United States Patent and Trademark Office

APPLICATION NO.	FILING DATE	FIRST NAMED INVENTOR	ATTORNEY DOCKET NO.	CONFIRMATION NO.
10/045,416	10/26/2001	David J. Kunst	A-70429/ENB	9958
7	590 09/16/2004	EXAMINER		
FLEHR HOH	BACH TEST ALBR	DEB, ANJAN K		
Suite 3400				
Four Embarcadero Center			ART UNIT	PAPER NUMBER
San Francisco, CA 94111-4187			2858	
			•

Application No.	Applicant(s)			
•		10/045,416	KUNST ET AL.			
	Office Action Summary	Examiner	Art Unit			
		Anjan K Deb	2858			
The MAILING DATE of this communication appears on the cover sheet with the correspondence address Period for Reply						
A SHORTENED STATUTORY PERIOD FOR REPLY IS SET TO EXPIRE 3 MONTH(S) FROM THE MAILING DATE OF THIS COMMUNICATION. - Extensions of time may be available under the provisions of 37 CFR 1.136(a). In no event, however, may a reply be timely filed after SIX (6) MONTHS from the mailing date of this communication. - If the period for reply specified above is less than thirty (30) days, a reply within the statutory minimum of thirty (30) days will be considered timely. - If NO period for reply is specified above, the maximum statutory period will apply and will expire SIX (6) MONTHS from the maili

Fig. 5. (US 5,059,916) (Ir, Ia, Ic and corresponding arrows have been added by examiner for indicating current flow).

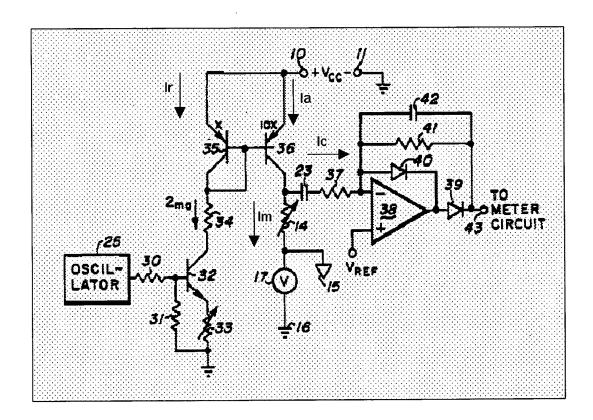
Re claim 1, (as best understood), Johnson discloses apparatus for determining a state of a measurable circuit element 14 having a plurality of states and a different impedance (variable resistance) in each state comprising a replicate circuit (35,34,32,33) configured to generate an adjustable test current and a trim determination circuit (36,14) coupled with the replication circuit for receiving the adjustable test current the trim determination circuit including the measurable circuit element 14 configured to compare (Ia –Im) the adjustable test current (Ia) to a current through the measurable circuit element (Im) to indicate at least one of the states (resistance) of the measurable circuit element 14 (column 3 lines 50-64)(please see Fig. 5 shown

Re claim 2, Johnson discloses replicate circuit comprising resistors (33,34) having similar electrical characteristic (resistance) providing feedback 31 indicative of the amount of adjustable test current (Fig. 5).

Re claim 3, Johnson discloses circuit generates a test current (10x) which is proportional to the adjustable test current (x) whereby the test current (10x) is passed through the measurable circuit element 14 such that a first voltage drop occurs across the measurable circuit element that is proportional to the impedance of the measurable circuit element.

Re claim 4, Johnson discloses measurable circuit element 14 has a lower voltage potential terminal whereby a voltage indicative of the state of the measurable circuit element 14 is measurable at the lower voltage potential terminal (-ve terminal of op-amp 38).

Re claim 5, Johnson discloses circuit has a scaled reference current source for generating a scaled reference current source 17 (V) and a dependent measurable current source 36 coupled with the scaled reference current source for generating a measured current (10x) whereby the amount of the measured current is a function of the first voltage drop across the measurable circuit element 14 and the state of the measurable circuit element is determined by the difference between the scaled reference current (produced by source V) and the measured current (10x).

Re claim 6, Johnson discloses replicate circuit including threshold current source 32 with feedback 31 for adjusting current.

Re claim 7, Johnson discloses trim circuit has a scaled current source (V) coupled to measurable current source (36).

Re claim 8, Johnson discloses all of the claimed limitations including first sense voltage (Vref) being supplied to second input (+) of amplifier 38 configured to generate an output proportional to the difference between measured voltage proportional to voltage across element 14 and a sense voltage (Vref).

Re claim 9, Johnson discloses replicate circuit having similar electrical characteristics (resistors) and adjustable test current (35,32,33,31).

12. In response to applicant's arguments regarding rejection under 35 U.S.C. 102(b) of claims 1-9, that Johnson fails to teach a replicate circuit including a replicate circuit element configured to generate an adjustable test current indicative of one of the plurality of states, and that Johnson does not disclose generating an adjustable test current that is indicative of a state of a measurable device. Claims are given their broadest reasonable interpretation consistent with the supporting description (MPEP 2111). In the instant case, Johnson discloses a circuit (35,34,32,33) which is broadly interpreted as a replicate circuit configured to generate an adjustable test current (Ia)(illustrated by examiner in the Figure shown below) and a circuit (36,14) broadly interpreted as a trim determination circuit coupled with the replication circuit for receiving the adjustable test current, the trim determination circuit including the measurable circuit element 14, and utilizing the adjustable test current to indicate at least one of the states (resistance) of the measurable circuit element 14 (column 3 lines 50-64)(Fig. 5).

element. Applicant is referred to the Figure shown below wherein a trim determination circuit configured to compare the adjustable test current to a current through the measurable circuit element and indicating at least one of the states of the measurable circuit element is shown. As stated above the circuit (36,14) is broadly interpreted as the trim determination circuit which is coupled with the replication circuit (35,34,32,33) for receiving the adjustable test current (Ia), and based upon a comparison of the adjustable test current (Ia) to a current through the measurable circuit element (Im) a state of the measurable circuit element 14 is determined. The state of the measurable circuit element 14 would be determined by knowing its resistance as measured by the meter circuit 43 since the input signal (Ic) to the inverting input (-) of Opamp 38 is a function of the current (Im) passed through the measurable circuit element 14 as determined from the following relation (Ic = Ia –Im). Therefore, Johnson discloses measurable circuit element 14 configured to compare (Ia –Im) the adjustable test current (Ia) to a current through the measurable circuit element (Im).
